POLICY REPORT
DEVELOPMENT AND BUILDING

Report Date: September 10, 2013
Contact: Kent Munro
Contact No.: 604.873.7135
RTS No.: 10248
VanRIMS No.: 08-2000-20
Meeting Date: September 24, 2013

TO: Vancouver City Council
FROM: General Manager of Planning and Development Services
SUBJECT: CD-1 Rezoning: 2290 Main Street

Figure 4: Mezzanine Level

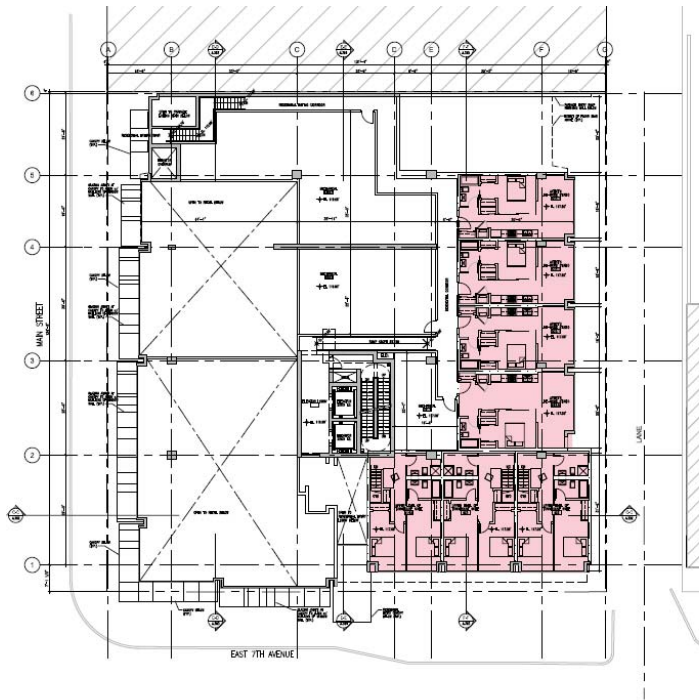
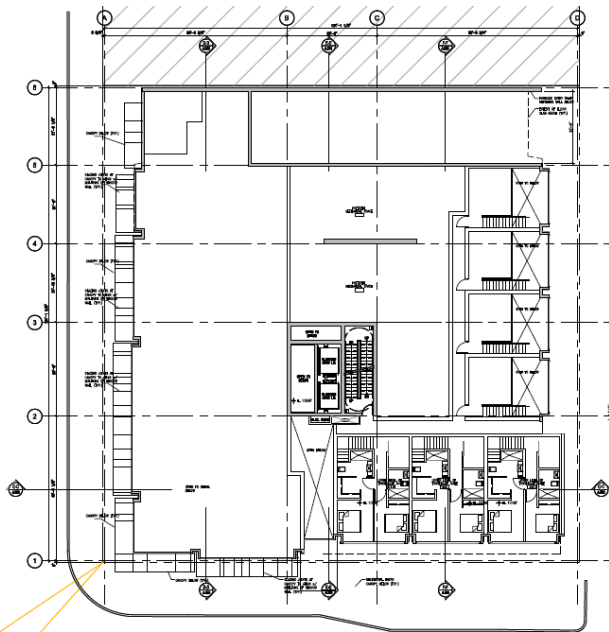
- 1. Design development to reduce the building height by two feet.
- 2. Design development to delete live-work units at the mezzanine level facing the lane and to convert the ground floor live-work units facing the lane into two-level units with the second floors set back a minimum 10 feet from the face of the building.

B: floor plan of the mezzanine level based on staff recommendation to delete four units facing the lane

Figure 11: North-South Section

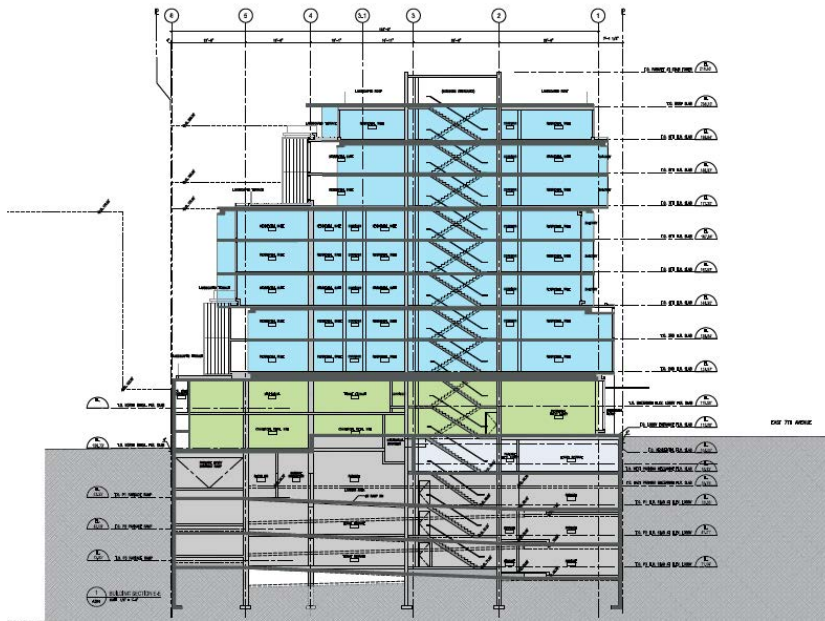
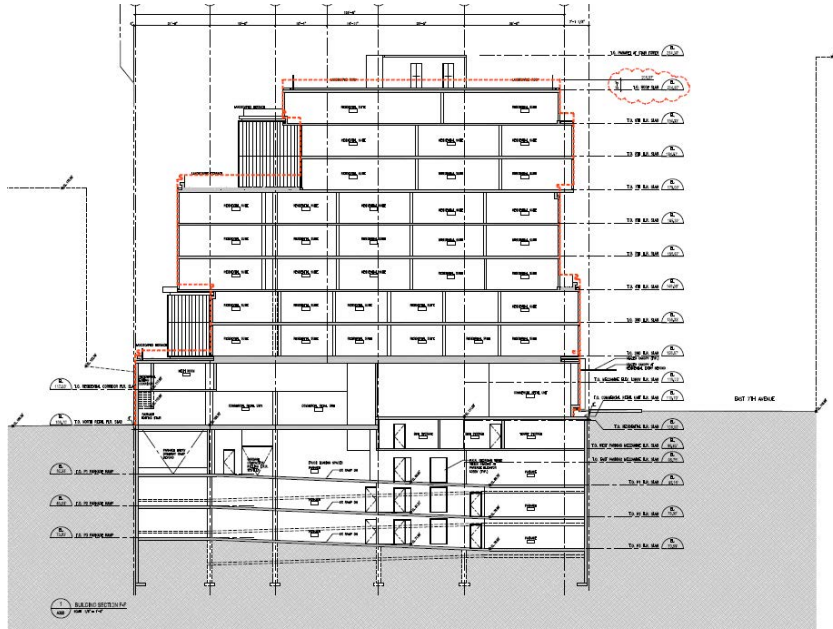
B: revised north-south section based on staff recommendation to reduce height by two feet
